# Groundwater Review Summary Form

Application # G- 18382

GW Reviewer M. Thome Date Review Completed: 12/12/16

TO: Water Rights Section Date December 12, 2016  
 FROM: Groundwater Section Michael J Thoma  
 Reviewer's Name  
 SUBJECT: Application G- 18382 Supersedes review of \_\_\_\_\_  
 Date of Review(s) \_\_\_\_\_

### Well Log Statistics from Sections Surrounding the Proposed POAs

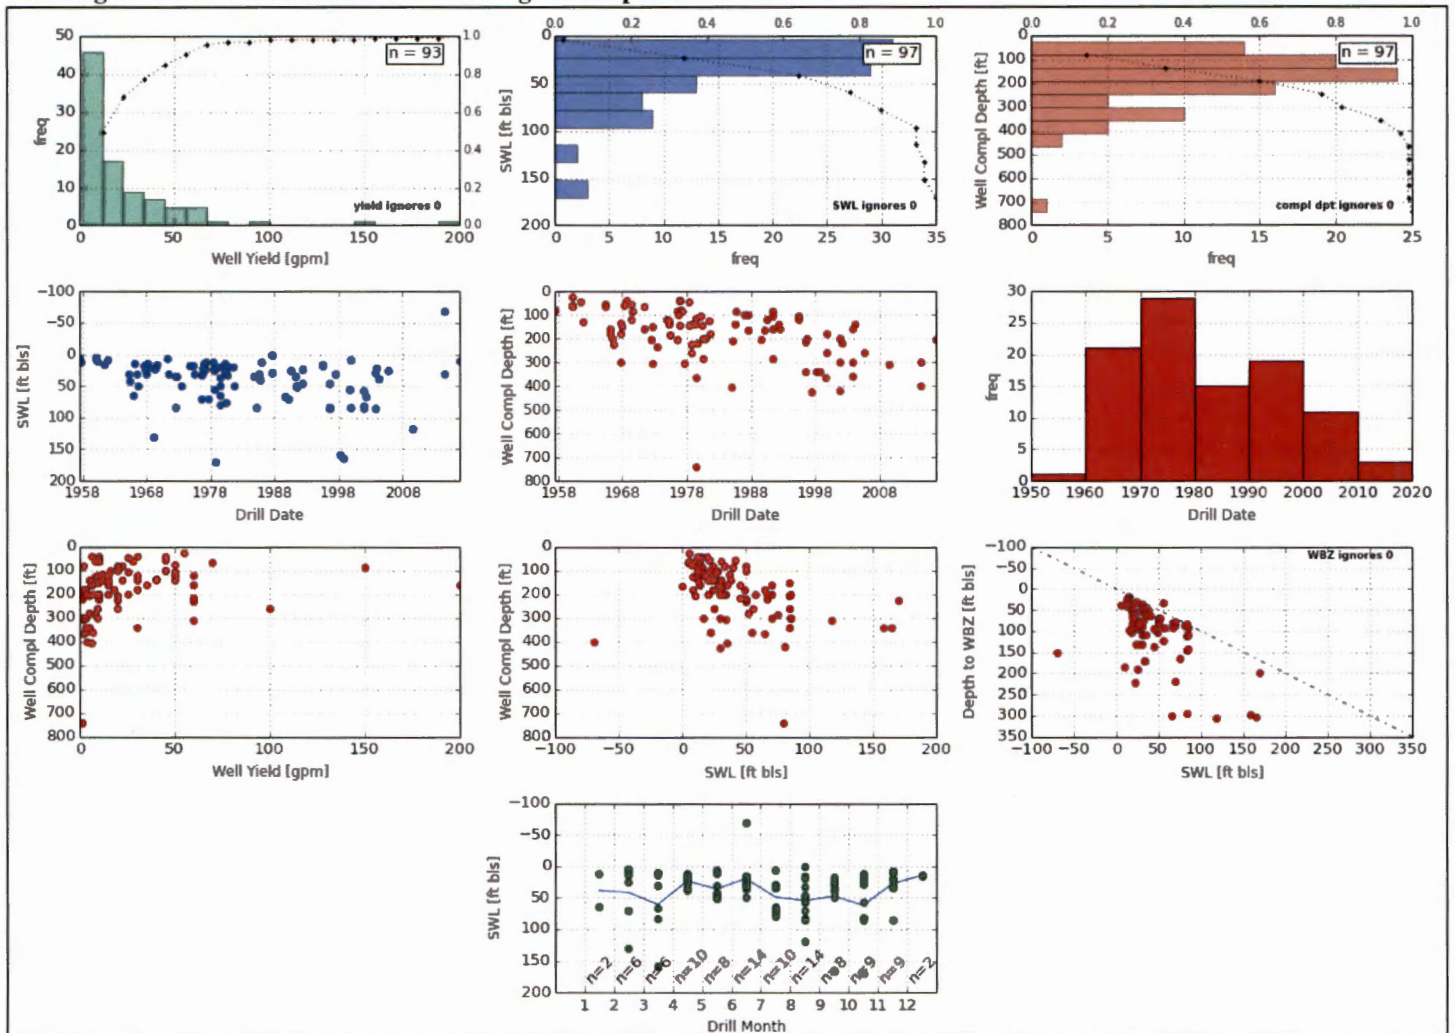
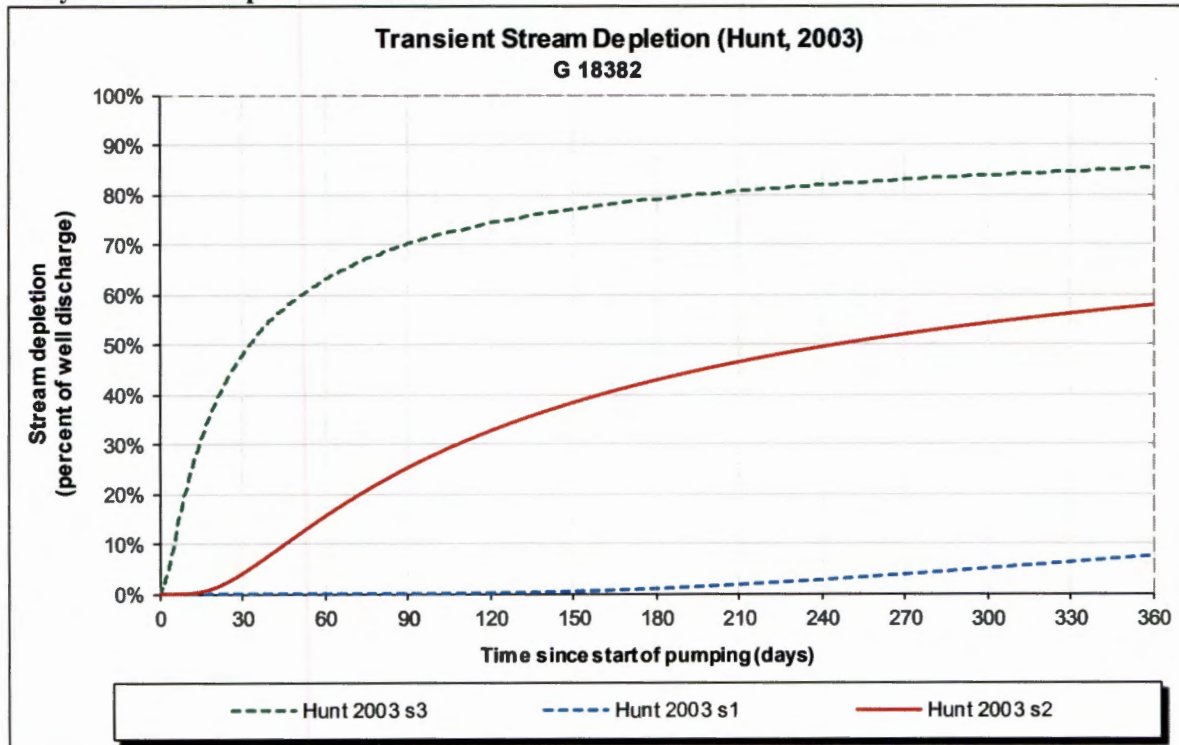
The proposed rate of 1.97 cfs (880 gpm) is far beyond the capacity of the groundwater resource of the area. Median well yield is approx. 12 gpm (n = 93) and the 90%-exceedance yield is 50 gpm so producing the requested 1.97 cfs is highly improbable from only two wells and would likely require many wells to produce. Such high pumping volume from multiple wells would cause significant drawdown in the aquifer which could severely injure nearby groundwater users (both exempt and non-exempt users).
